Technical Bulletin

Single-Double Inner Fork Control Gas Cylinder Identification and Modifications

Configuration 1 - Non Current

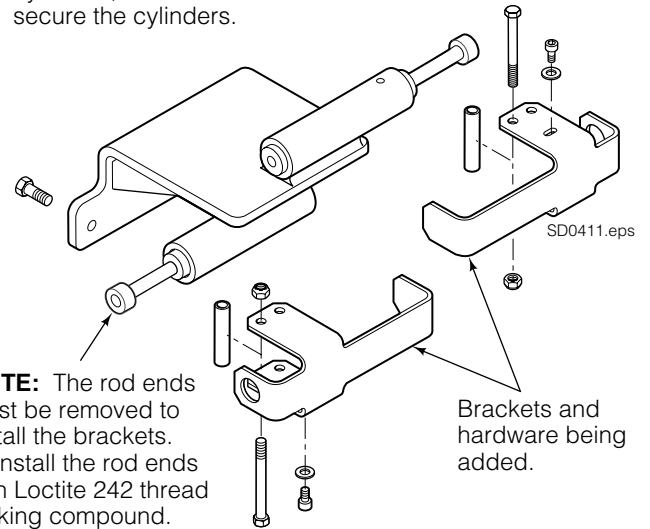
This Bulletin describes how to identify and modify Single-Double Pallet Handlers with early style inner fork control gas cylinders. When worn or damaged the gas cylinders can disengage from the anchor bracket and cause machine damage or personal injury. The two different style gas cylinder configurations have a service kit or brackets available to securely retain the gas cylinders. Order the appropriate service kit or brackets and install as shown.

If you have this style inner fork control cylinders, order bracket kit 6116937 to secure the cylinders.
